METRO RTA - 40 Ft. GILLIG LOW FLOOR

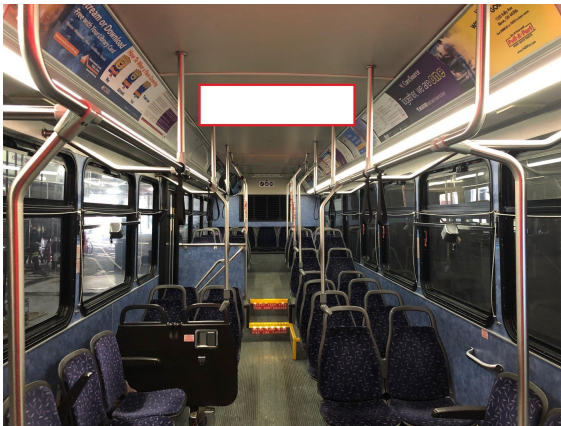
a. Can NEORide please provide internal pictures of each bus type to assist in determining the optimal placement and sizing of the signs?

Yes - See picture from 10.a for METRO RTA Answer

METRO RTA - See 10.a

SORTA On-Board Technologies

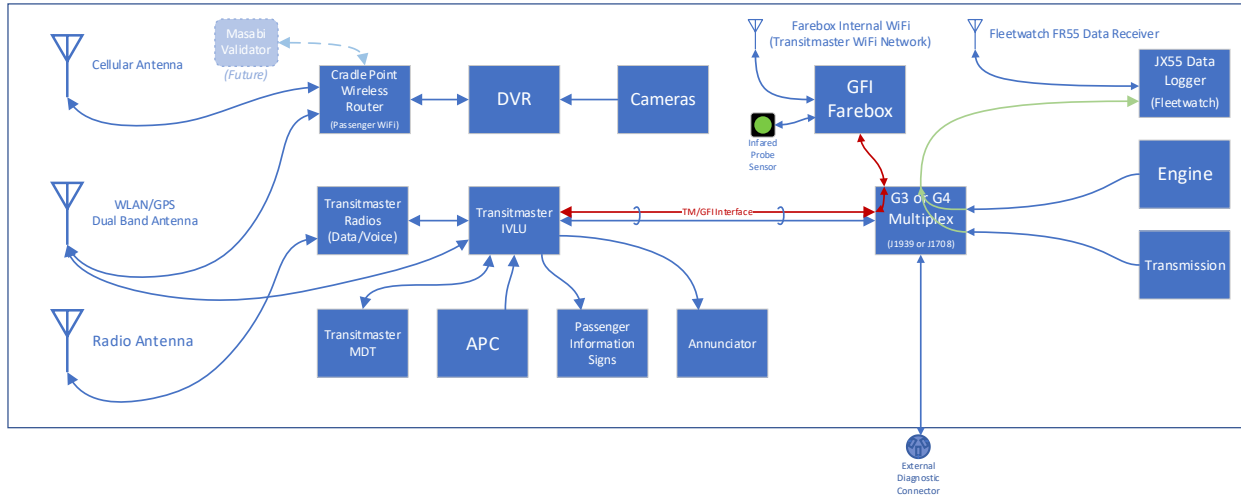
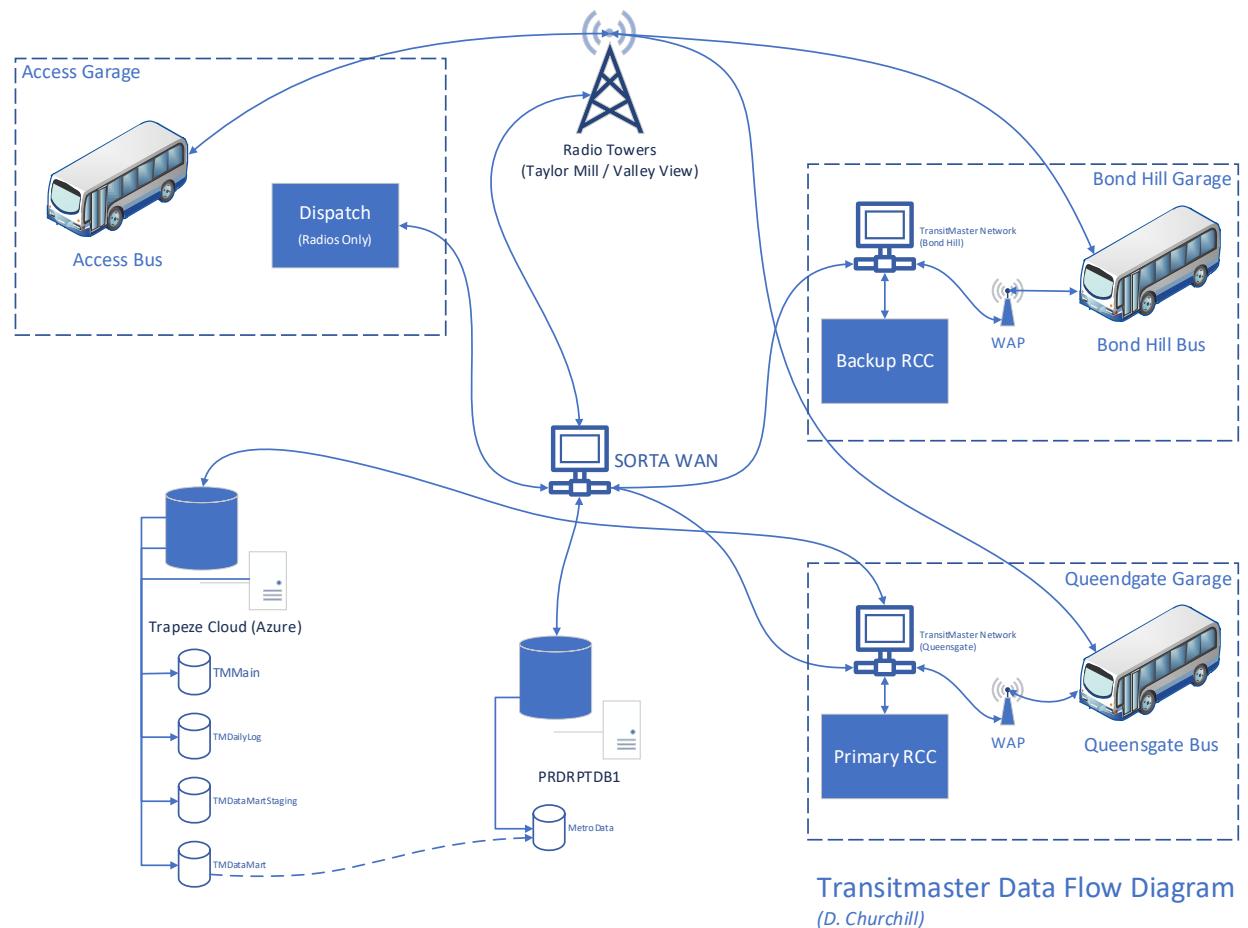
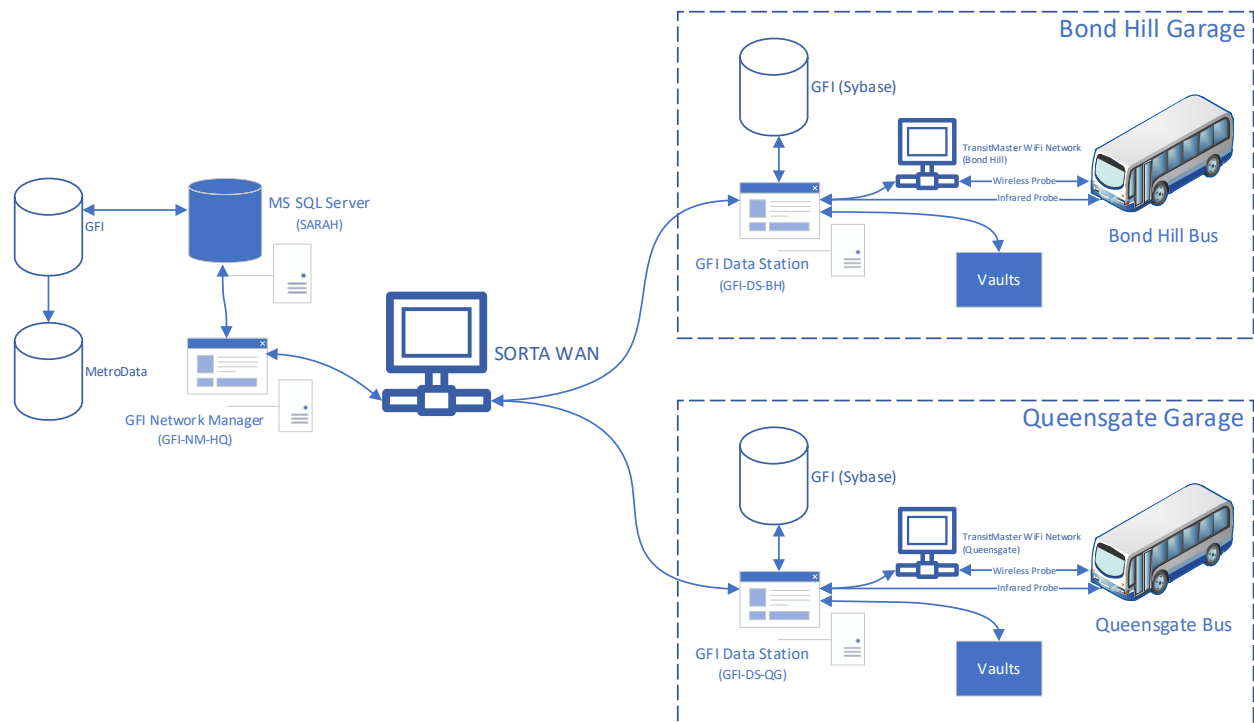
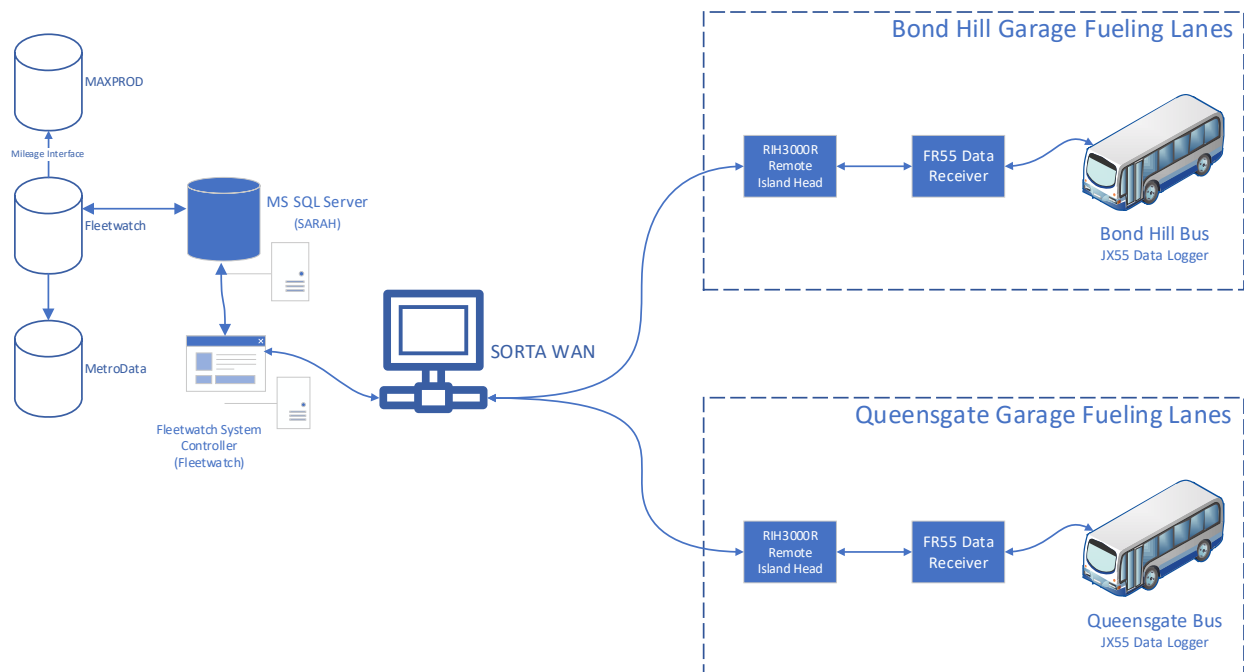
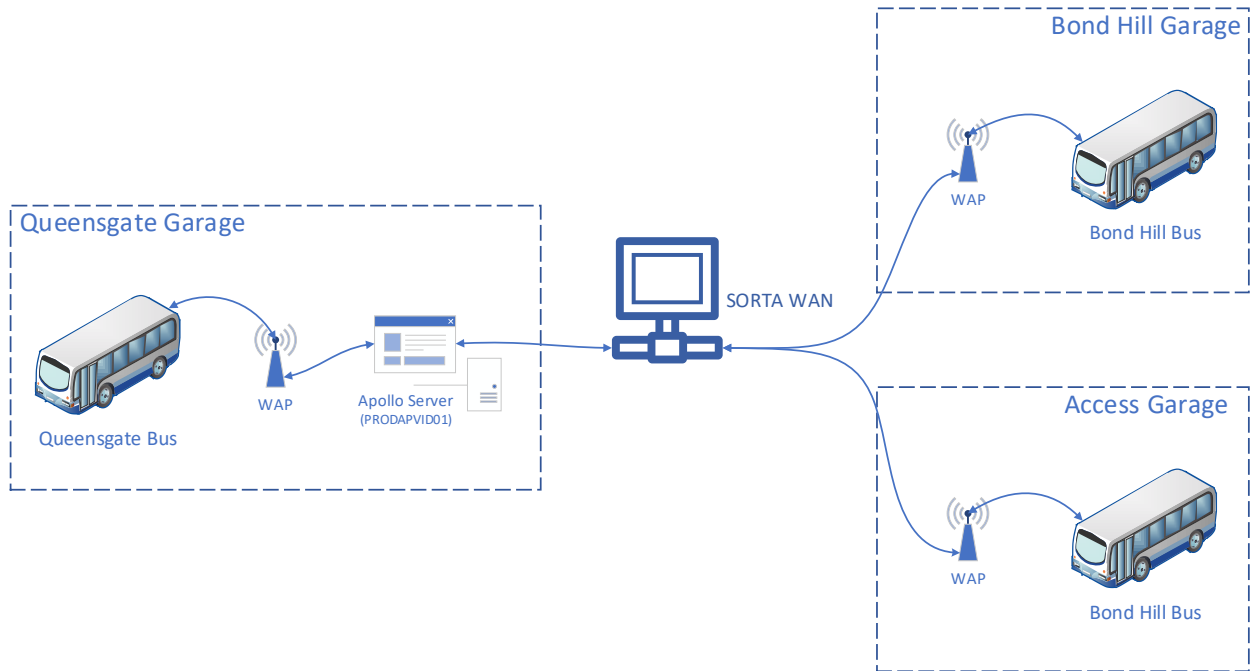
10. Can NEORide please provide a detailed vehicle inventory for each agency and all vehicles to be involved in project? Please include information regarding make, model, year, external/internal speakers, existing equipment to be removed, and existing equipment with which to be integrated (i.e. routers).

27. Please provide system diagrams for the existing on-board electronics. In particular please provide information regarding types of connectivity to be used (i.e. CAT-5, RS-232, etc.) between the existing system and the signage. (This is to allow us to evaluate the manner in which the new system is to be integrated into the existing system.)

SORTA has provided a PDF of all on-board technologies. Please see attachment at the end of this document.

SORTA diagram has been provided (CBC will model same)
